DATAFILE BULLETIN

FILE UNDER: Receivers
 ER-42-A, B & C
 BULLETIN NO 1086-4
 DATE: November 1967

Equipment: 406—470 MHz MASTR Professional Receivers

Symptom: **AUDIO OUTPUT TRANSISTOR FAILS**

Figure 1 - Showing Diode Added

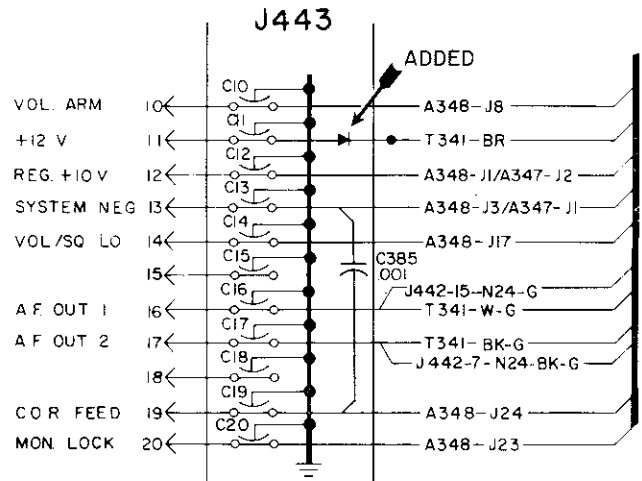
Cause: Negative voltage spikes, induced in the supply lead by external transients.

This revision added a diode in series with the +12 VDC supply lead to prevent negative spikes from reaching the output transistor. See Figure 1.

Field Solution: The diode should be added to receivers which do not have it, as shown in Figure 1. Connect the anode lead to J443-11 and the cathode lead to the brown wire from the audio output transformer. Use sleeving where necessary.

Ordering Info:	Symbol Number	GE Part No.	Description
	CR401	4037822-P1	Diode, silicon: PIV 400, sim to SC4.
